CITY OF ALBUQUERQUE

**RE: L&C Transport Office and Shop
108 94th St NW
Conceptual Grading and Drainage Plan
Engineer's Stamp Date 4/25/18
Hydrology File: K09D043**

Based on the information provided in your submittal received 5/1/18, the above referenced plan cannot be approved until the following are addressed:

By: WTB
GRADING & DRAINAGE PLAN
Sheet: Of:
C-100

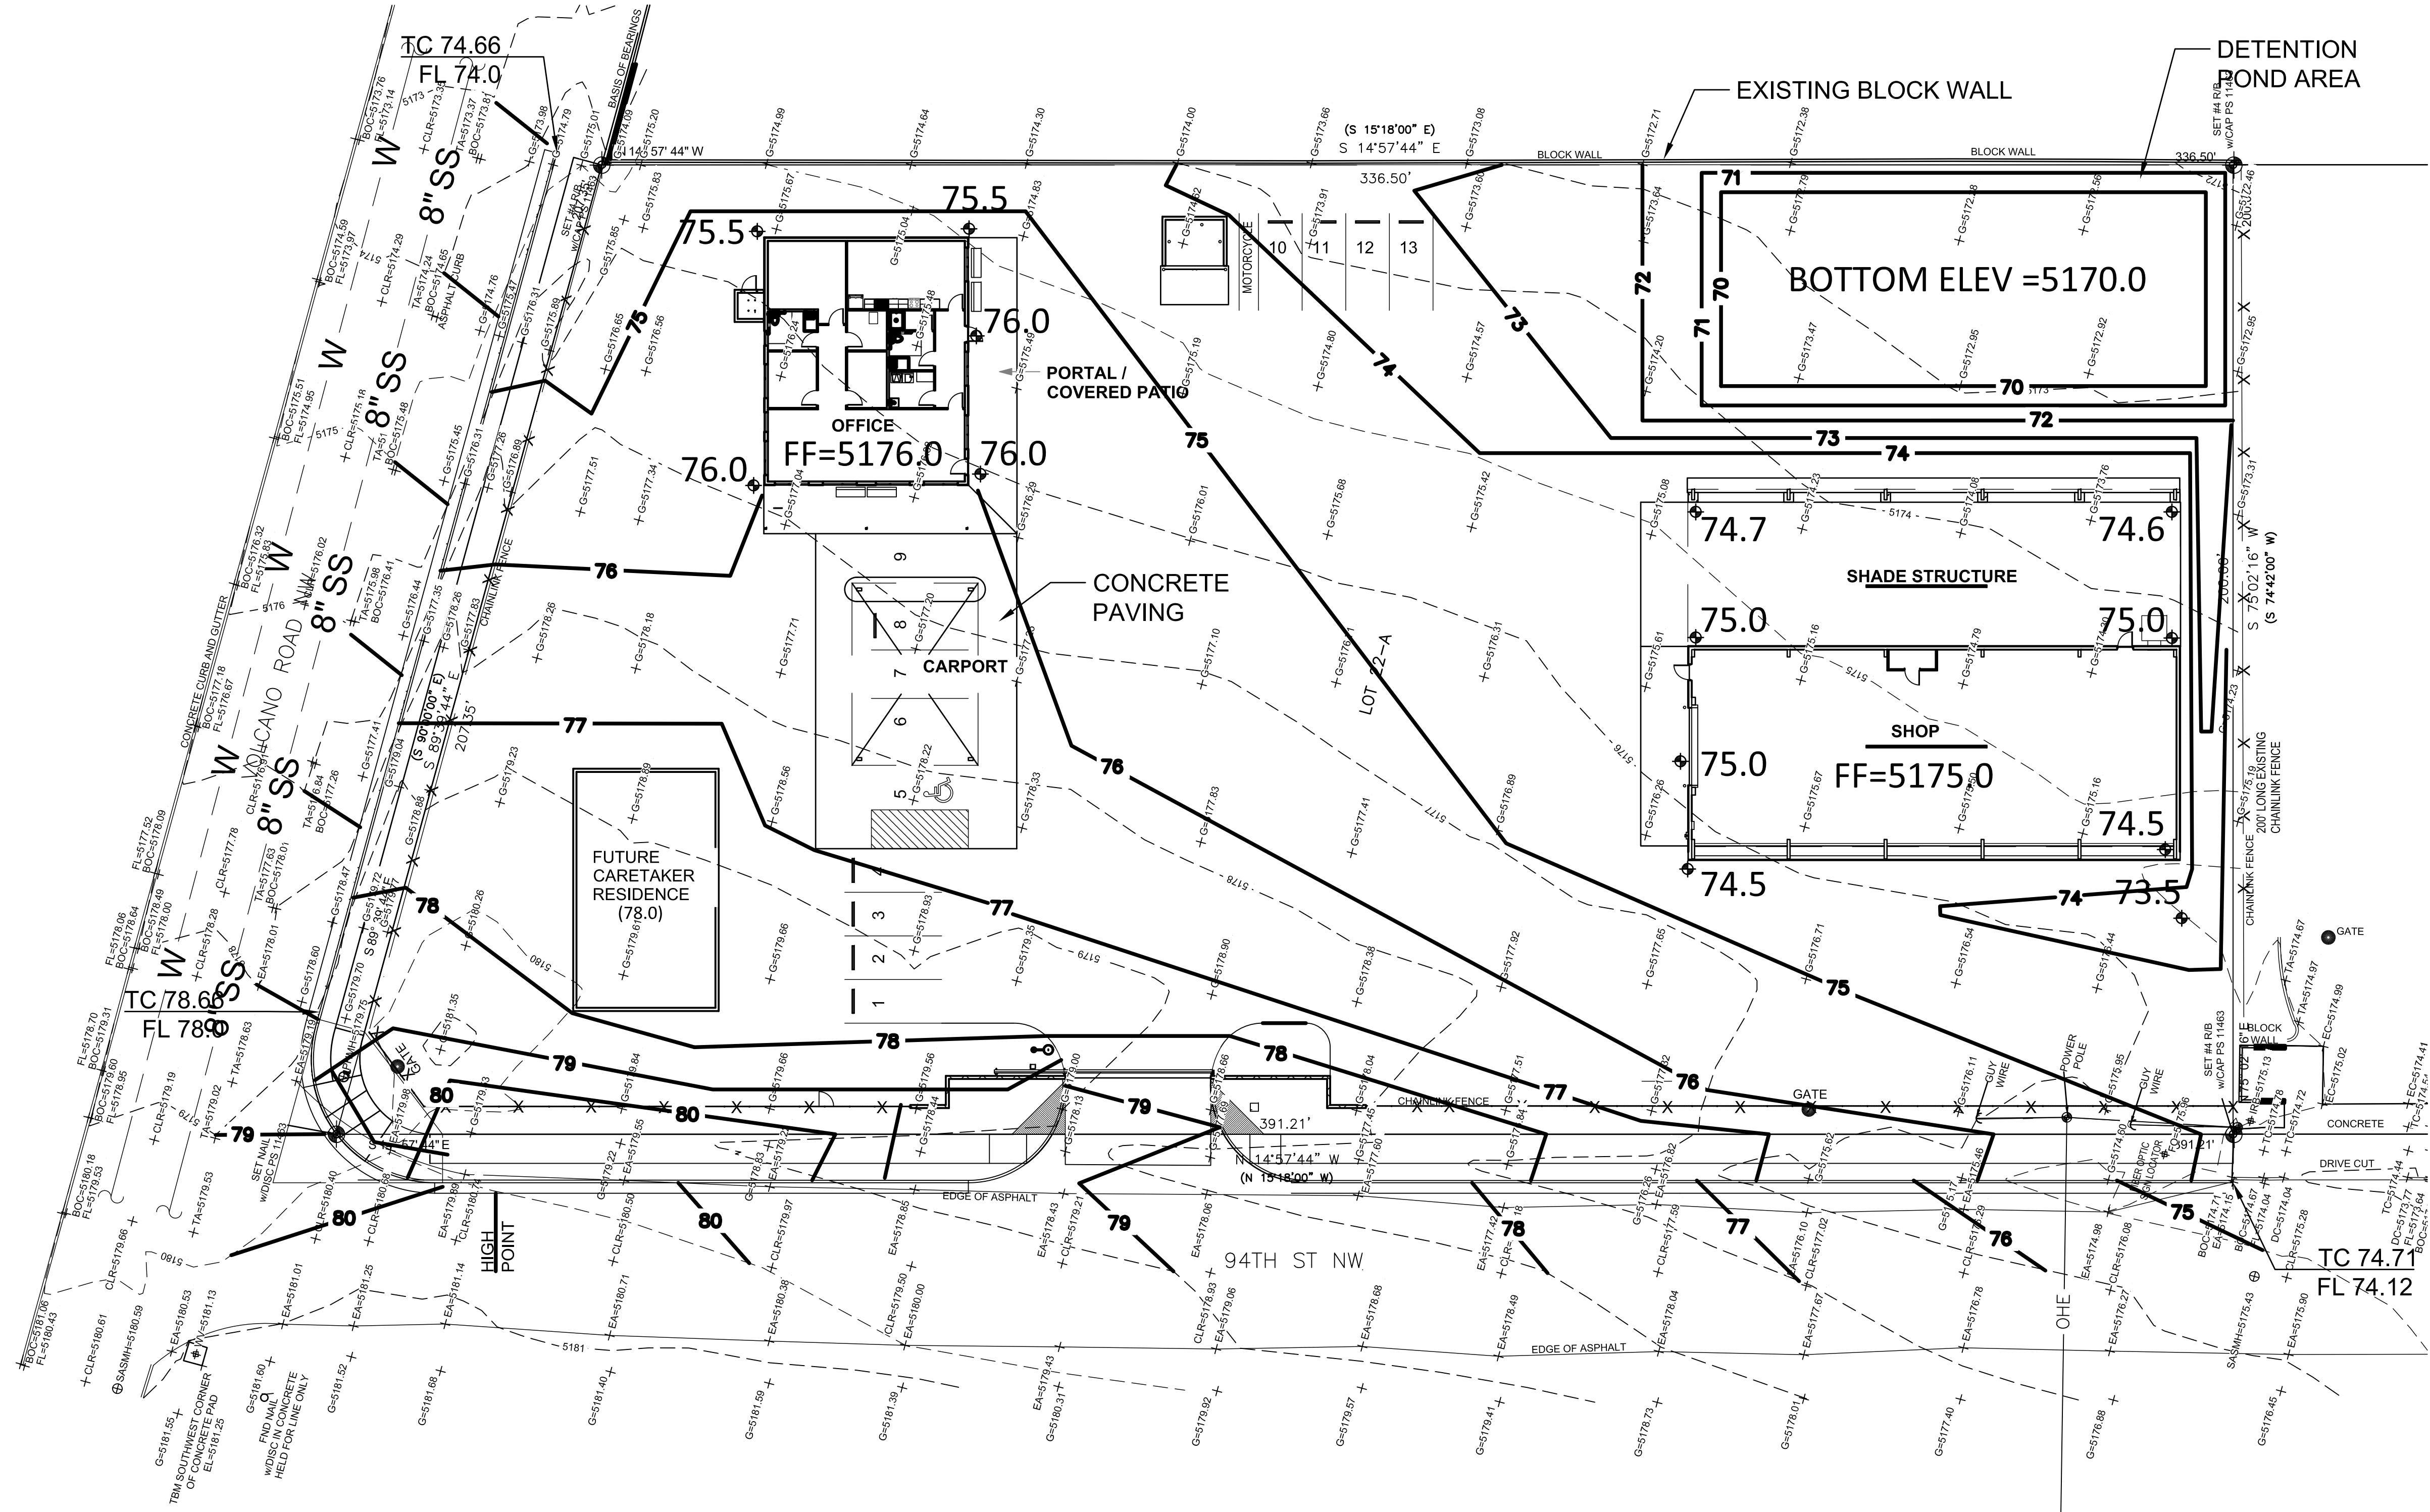
1. Provide valley gutter across 94th St at the intersection of 94th and Volcano.
2. On the retention pond, provide a non-erosive emergency overflow, sized for the 100-yr peak inflow.
3. Provide a 0.87' waterblock at the entrance to your site.
4. Add note on the plan that "No work shall be performed in the public ROW without an approved Work Order or Excavation Permit."

5. Provide additional detail along the eastern property line and existing block wall. It appears that a swale or berm will be needed here to keep flows away from the block wall and conveyed into the retention pond.
6. Provide section views though the pond and adjoining property lines. If a berm is required, it will need to comply with Ch. 22, section 3, part F.
7. A Drainage Covenant (No Public Easement) is required for the stormwater retention pond. The original notarized form, exhibit A (legible on 8.5x11 paper), and recording fee (\$25, payable to City of Albuquerque) must be turned into DRC (4th, Plaza del Sol) for

8. Remove all "Conceptual" markings.
9. This project requires an ESC Plan, submitted to the Stormwater Quality Engineer (Curtis Cherne PE, ccherne@cabq.gov or 924-3420).
10. Additional comments may be provided at Building Permit, based on the outcome of the above remarks and level of detail shown on plans.
